# SERVICE BULLETIN REVISION NOTICE

ENGINE — CONVERSION — PROVIDE INSTRUCTIONS TO CHANGE THE V2500-A5 ENGINE RATING BY MODIFYING THE DATA ENTRY PLUG

Turbojet Engine Service Bulletin No. V2500-ENG-72-0285 Revision No. 12 dated March 30, 2016.

ENGINE RATING INDICATOR  
FIGURE 4, SHEET 3

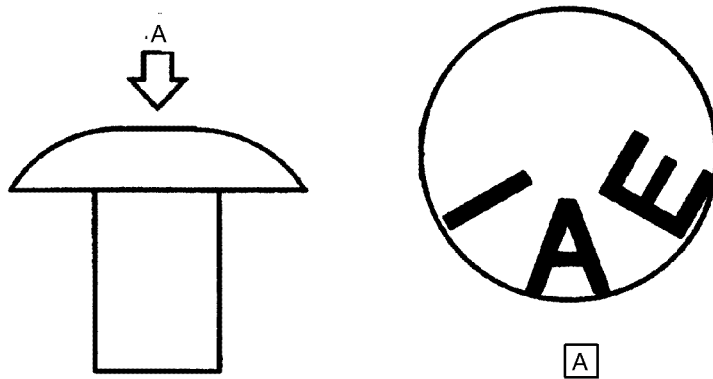
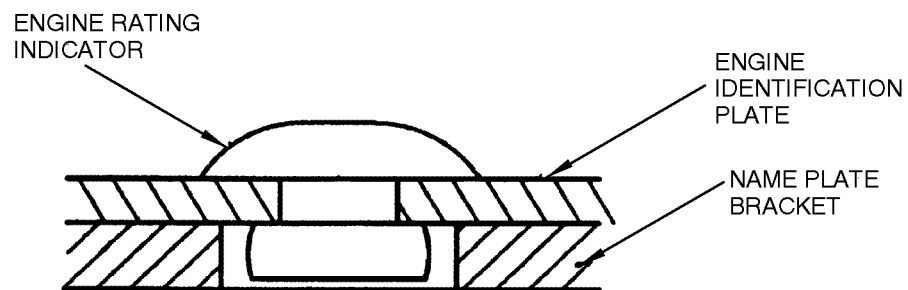
To revise Figure 5 and Title of Figure 4, Sheet 3 in the Accomplishment Instructions.
